# **Site Plan Application City of Portland, Maine**

**Kitchen & Dining Hall Addition  
The Salvation Army Adult Rehabilitation Center  
88 Preble Street  
Portland, Maine**

January 18, 2016

**RE: Level II Site Plan Application  
Salvation Army Building Addition  
88 Preble Street  
Portland, Maine**

A104

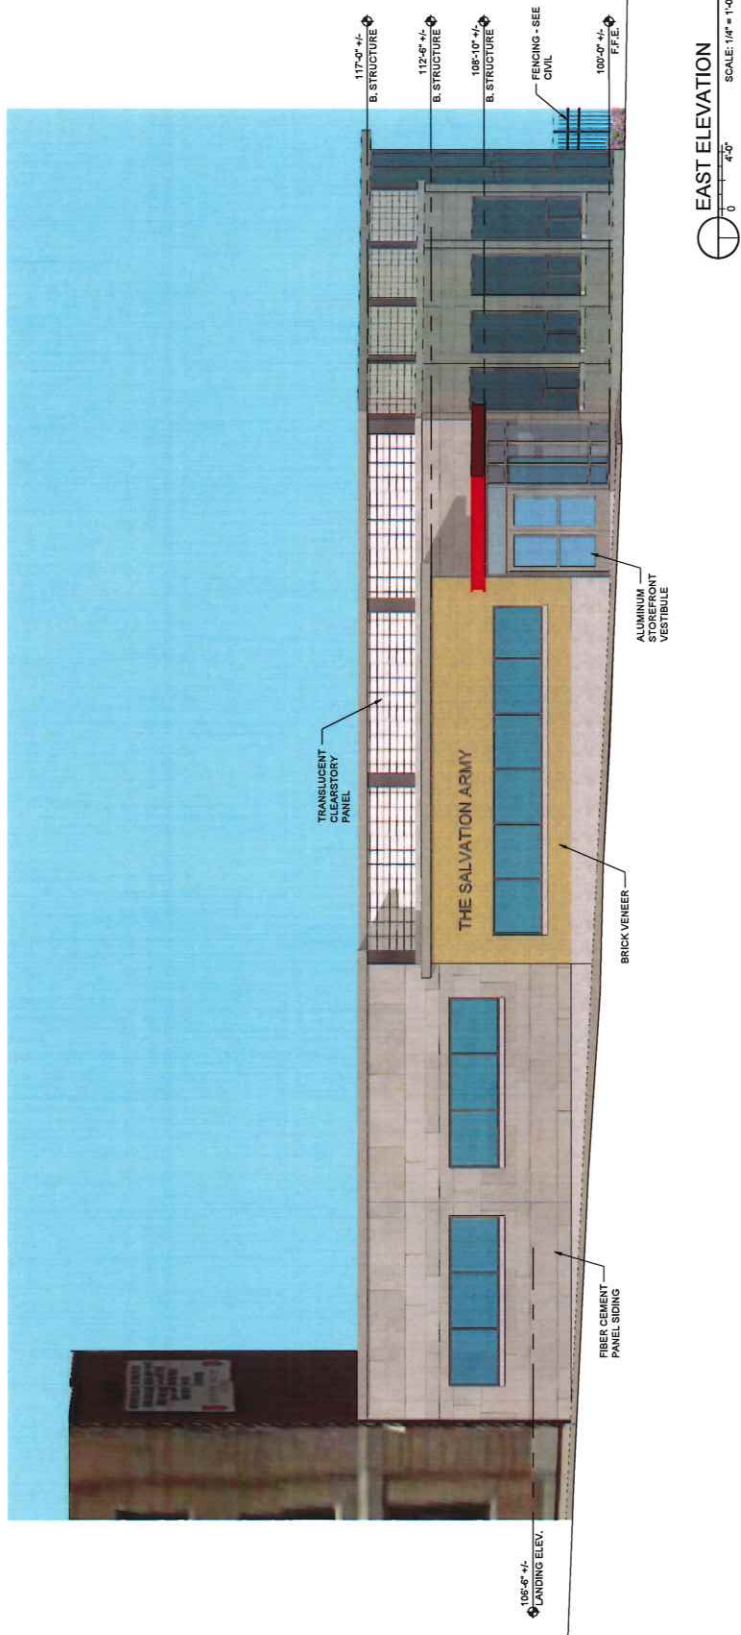
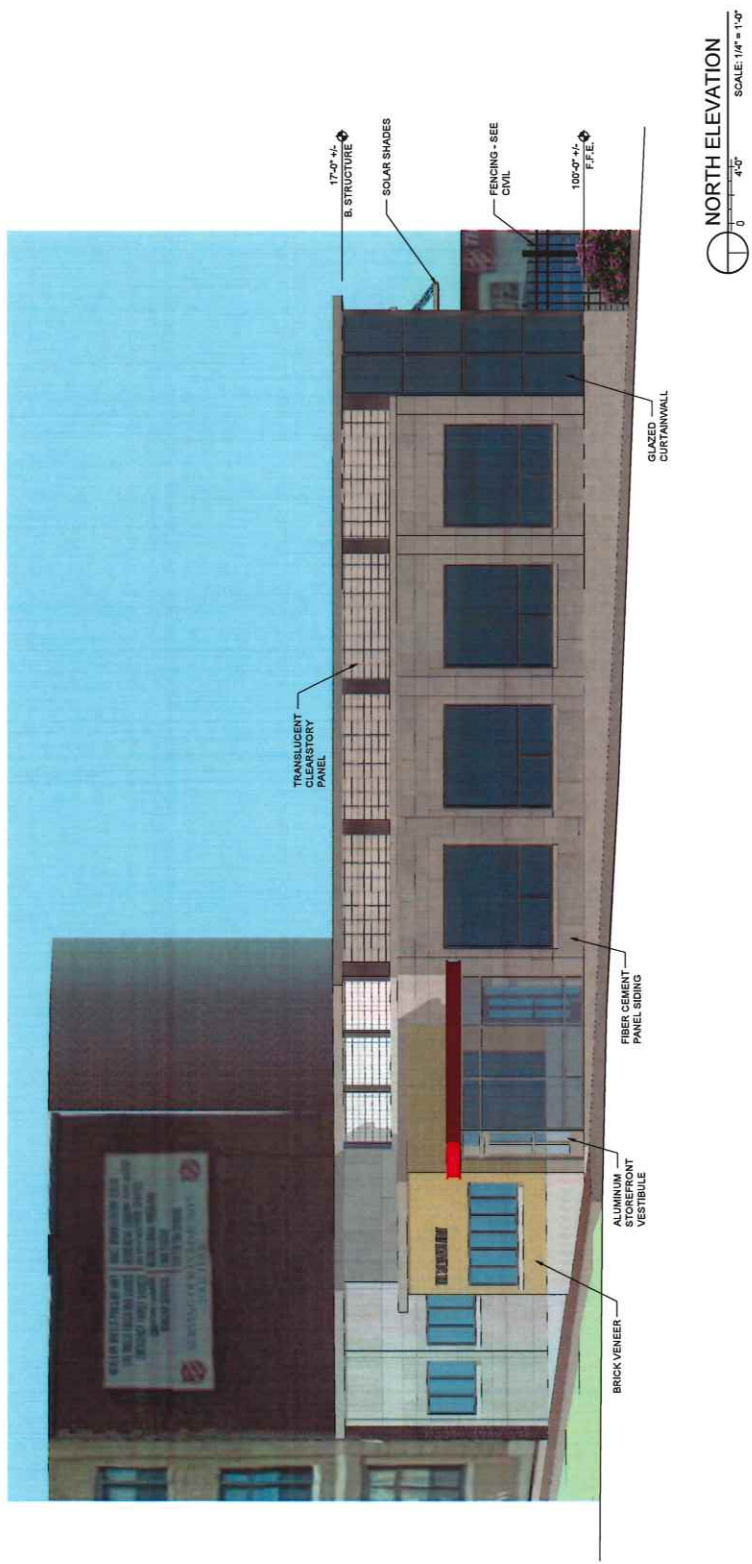
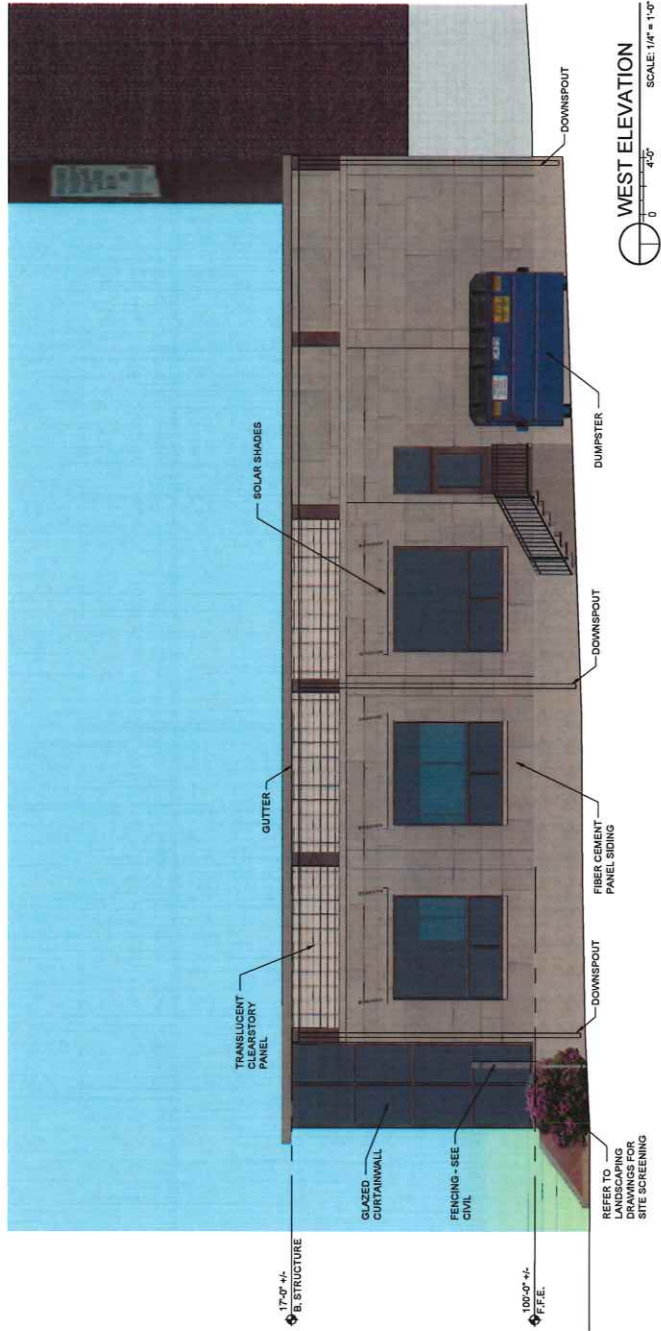
- The location of a sewer under the dumpster is not good practice/could be problematic;
- The dumpster needs to be screened;
- We would recommend something more durable than fiber cement panel siding;
- We welcome the decorative wrought iron fencing but are not sure about the planting being outside the fence;
- Why is the new sidewalk partly on your property? (The upgraded sidewalks welcomed though?!)

- ✓ The location of a sewer under the dumpster is not good practice/could be problematic;
- The dumpster needs to be screened;
- We would recommend something more durable than fiber cement panel siding;
- ✓ We welcome the decorative wrought iron fencing but are not sure about the planting being outside the fence;
- ✓ Why is the new sidewalk partly on your property? (The upgraded sidewalks welcomed though?!)
